Proposed typical floor plan - Buildings 11 and 12

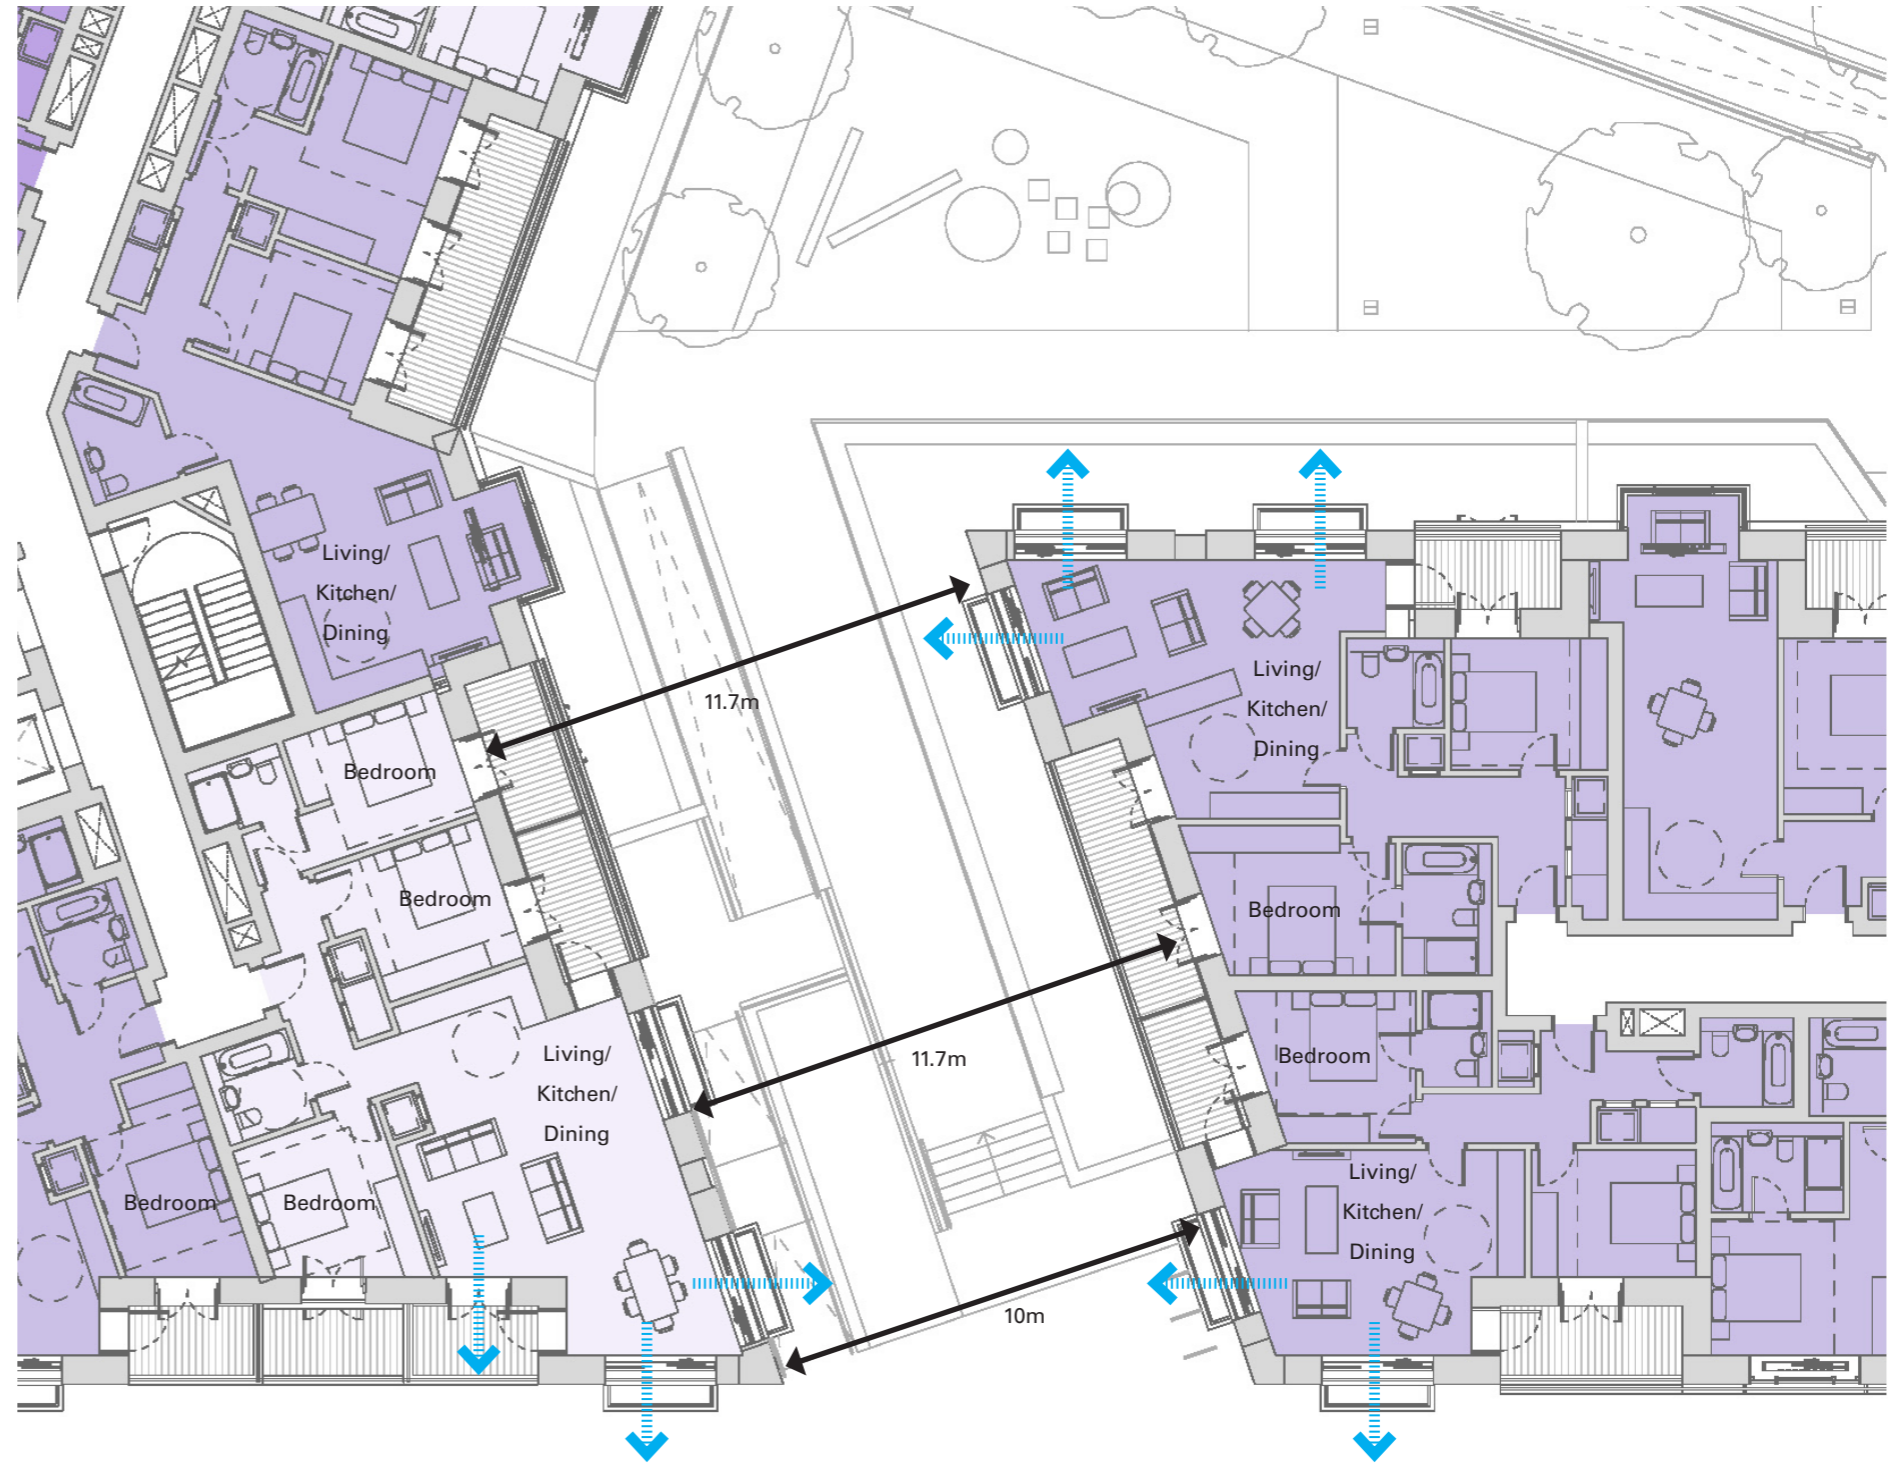
2. Block 11 with Block 12: Only 10m gap between and single aspect. Unacceptable living conditions.

3. Block 11 with 8: Only 15m and single aspect. Unacceptable living conditions.

Please refer to response to item 14 on Building 6 for an explanation of street widths.

We would note that all facing units are dual aspect and that living rooms are located on the corners of each of the units and therefore benefit from dual aspect. Bedrooms are provided on the set back areas of façade, are set apart by more than 13m and are screened by balconies and balustrades.

Please see section dedicated to 'Proximity of Buildings'.
